Gaertner Scientific Corporation
8228 McCormick Blvd., Skokie, IL 60076
tel 847 673 5006 fax 847 673 5009
www.GaertnerScientific.com

SERVICE DEPT. MEMO

RE: Modification Made to P/N 10257-10F Photodetector Board to Permit Higher Laser Beam Intensity Incident On Photodiode Cell

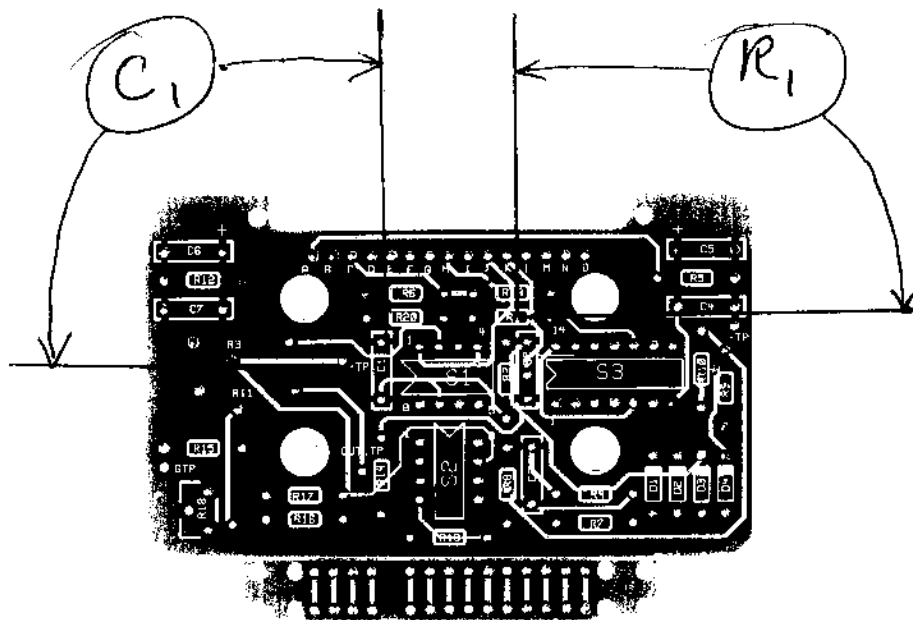
Specifically, the resistor at location R1 and the capacitor at location C1 (refer schematic) were replaced. Formerly, at R1 there was a 301k ohm resistor, and at C1, there was a 33 picofarad capacitor. These have since been replaced with a 100k ohm resistor and a 100 picofarad capacitor, respectively.

The printed "R1" and "C1" are difficult to see on the photodetector board because the components cover the print. To find the specific components look for the resistor (R1) nearest the number "14" and look for the capacitor (C1) nearest the label "TP".

- 1) If possible, boost the overall laser beam intensity exiting the polarizer by adjusting the beam attenuator at the forward area of the laser mount. If there is not sufficient adjustment at the attenuator, then apply one of the next remedies.
- 2) Replace the R1 resistor and C1 capacitor components with their old, original rated components as denoted above, or ship the photodetector board(s) to Gaertner Scientific for the explained alteration.
- 3) The last option is to replace the existing diffuse filter on the motor endplate with the newer diffuse filter that allows more light through.

follow the intersection of lines for C_1
& lines for R_1 to locate

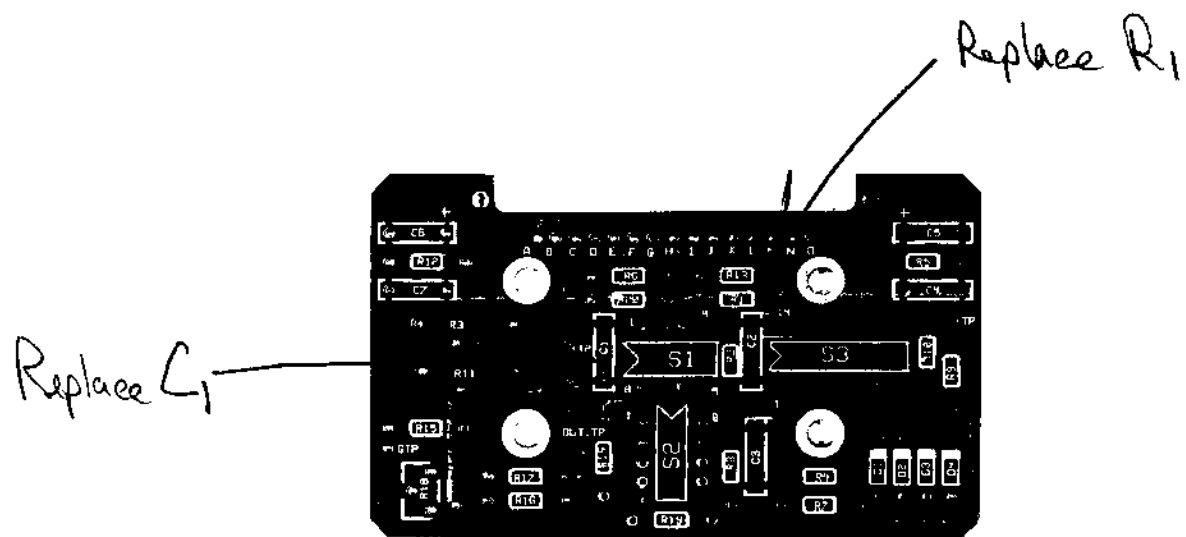
The diffuser used currently allows more light thru to PD. This improves the signal-to-noise ratio. As such, the PD board feedback gain must be reduced. Please replace the components indicated below with those provided with the diffuser

Replacement parts:

7108-E370A-100K
7108-E400A-101
